UNITED STATES PATENT AND TRADEMARK OFFICE

10/670,524

Office Action Summary	Application No. 10/670,524	Applicant(s) SAKIYAMA ET AL.	
	Examiner Felix O. Figueroa	Art Unit 2833

DETAILED ACTION

FIG. 7

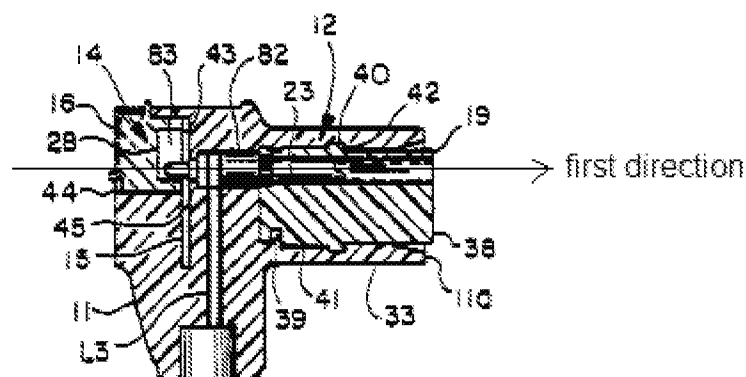
Guss discloses a connecting structure which connects auxiliary machinery to a cable (18) in which conductors (L1-L3) are surrounded by an insulating covering; and an auxiliary machinery (10) attached directly to this the cable the auxiliary machinery comprising: a housing (11) comprising a board (15) on which electronic components (26,28) are mounted and to which a specific circuitry pattern has been formed; a discrete connection terminal (23) connected to the circuitry pattern on the board and to at least one conductor among the conductors of the cable, extending in a first direction (see following figure) there-between, and comprising opposite ends in the first direction which terminate within the auxiliary machinery and are covered by the auxiliary machinery in the first direction (from left to right in the following figure); an exposed connecting portion configure to exposed the discrete connection terminal on an outer surface of the housing; and a molded part (16) for sealing a connection between the connection terminal and the at least one conductor of the cable.

Guss discloses substantially the claimed invention except for the flat configuration of the conductors. Fuchs teaches the use of conductors arrayed in a flat configuration. This flat configuration permits a reduction of the size/profile of the

Regarding claims 10 and 11, Guss discloses tow molded parts (16,19) provided, each one arranged to seal on of the opposite end portions of the connection terminal in the first direction. Please note that the molded part (19) seals (at least the outer surface of) the end portion (left side in Fig.7).

Regarding claims 19 and 20, Guss discloses the molded part covering both of the opposite end portions of the connection terminal in the first direction (from left to right in Fig.7).

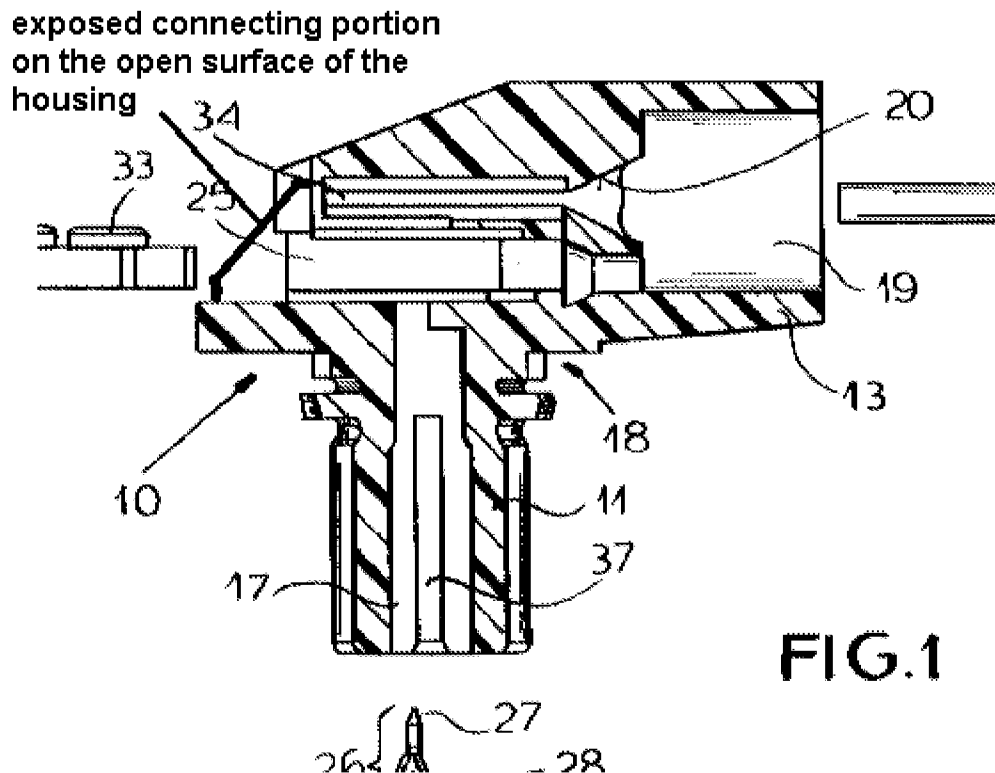
Guss discloses substantially the claimed invention except for the specific exposed connecting portion. Fuchs teaches an exposed connecting portion (see following figure) configure to expose a connection between the discrete connection terminal and at least one conductor of the cable on an outer surface, thus allowing easy insertion of the conductor and visual inspection of the connection between the conductor and the terminal. Therefore, it would have been obvious to a person of ordinary skill in the art at the time the invention was made to form an exposed connecting portion, as taught by Fuchs, to allow easy insertion of the conductor and visual inspection of the connection between the conductor and the terminal.

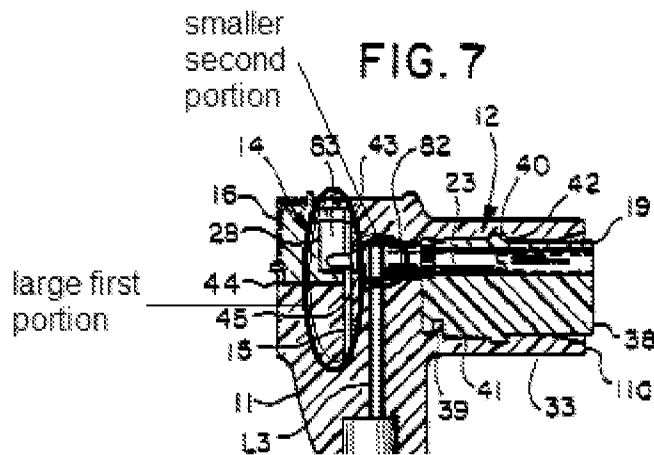
Guss discloses substantially the claimed invention except for the specific exposed connecting portion. Fuchs teaches an exposed connecting portion (see previous figure) configure to expose a connection between the discrete connection terminal and at least one conductor of the cable on an outer surface, thus allowing easy insertion of the conductor and visual inspection of the connection between the conductor and the terminal. Therefore, it would have been obvious to a person of ordinary skill in the art at the time the invention was made to form an exposed connecting portion, as taught by Fuchs, to allow easy insertion of the conductor and visual inspection of the connection between the conductor and the terminal.

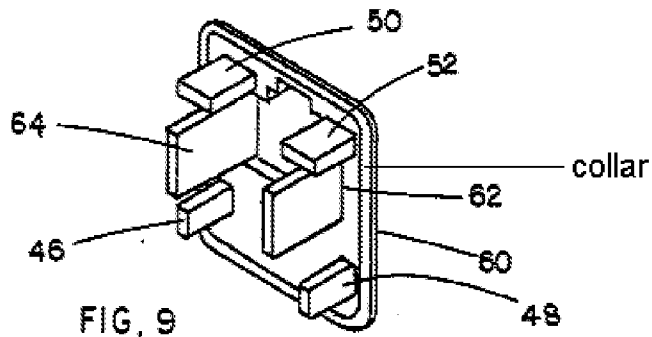
Guss, as modified by Fuchs, discloses substantially the claimed invention (see discussion on claims 1 and 3) except for the receiving member and the retainer. Arnett teaches a mounting structure for an auxiliary machinery / connector (60) directly coupled to a plurality of conductors (not labeled), mounted to a receiving member (22) with a mounting hole (24); wherein the distal end (right of 60 on Fig.2) of the housing

can engage the mounting hole; and a retainer (30) that attaches to the distal end of the housing and an outer periphery (at 32) of which engages in the mounting hole of the receiving member; wherein the auxiliary machinery is mounted to the receiving member by attaching the retainer in the mounting hole from one side of the receiving member (right side), and attaching the housing to the retainer from the other side of the receiving member (left side) to securely mount the auxiliary machinery onto a predetermined usage/working location (see abstract lines 22-26). Therefore, it would have been obvious to a person of ordinary skill in the art at the time the invention was made to mount the auxiliary machinery of Fuchs on a receiving member, as taught by Arnett, to securely mount the auxiliary machinery onto a predetermined usage/working location.

FIG. 3

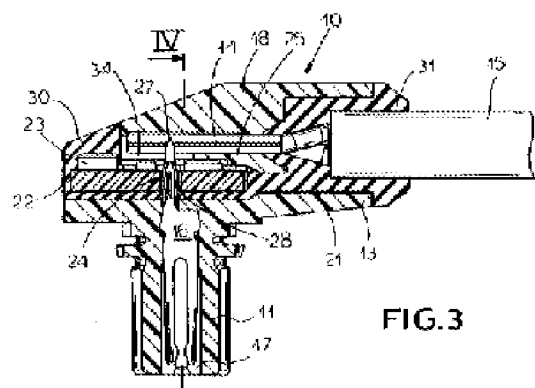
In response to Applicant's argument that neither Fuchs nor Guss, alone or in combination, disclose or suggest "at least that a first portion of said flat cable which extends from said connecting portion is provided on and extends along an outer surface of said auxiliary machinery", please note that, based on the right angle structures shown by Fuchs and Guss, after connection to the auxiliary machinery the cable will extend along an outer surface of the auxiliary machinery (see following illustration).
